1994 Texas Accessibility Standards
Technical Memorandum

Texas Department of Licensing and Regulation
Architectural Barriers

TM 00-02

Water Closets – Clear Floor Space
4.16.2

Fig. 28
Clear Floor Space at
Water Closets

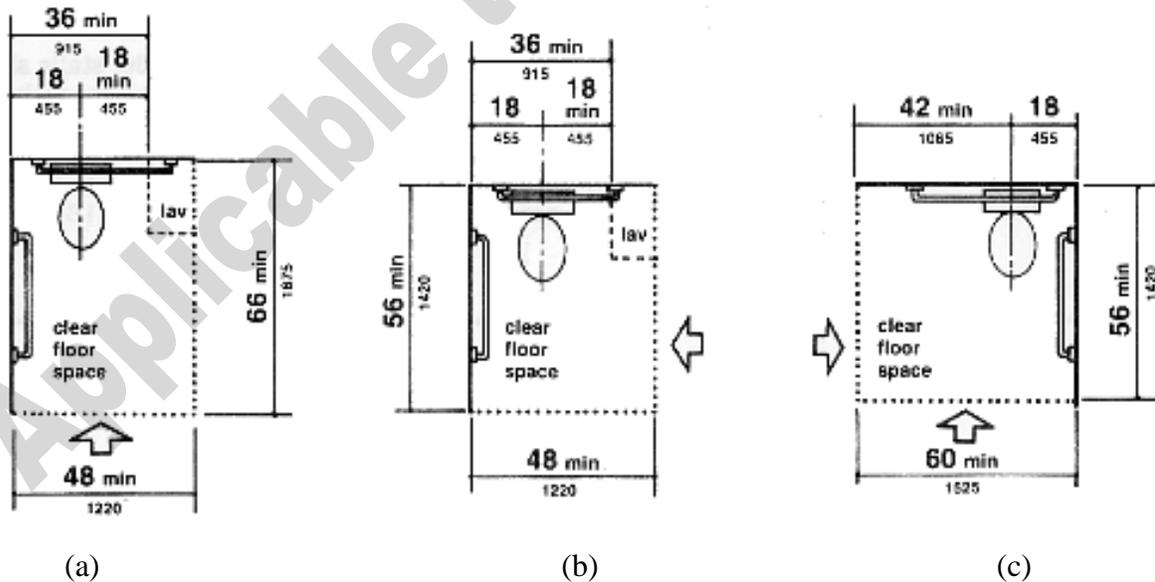
As presented in TAS, Fig. 28 of 4.16 can be misleading. For the purposes of clarification in this technical memorandum, the illustrations below will be referred to as (a), (b) and (c) and Fig. 28 should be considered as shown below. (Dotted lines do not represent walls)

Fig. 28 (c) represents the minimum clear floor spaces required for all water closets not located within toilet stalls. (60-inch wide clear floor space min. is required for all water closets.) Fig 28 (a) and (b) represent the minimum clear floor spaces required for water closets when a lavatory is provided on the same wet-wall adjacent to it and the clear floor space depth required for frontal and side approaches. (Graphics only show half of a lavatory, to it's center-line.)
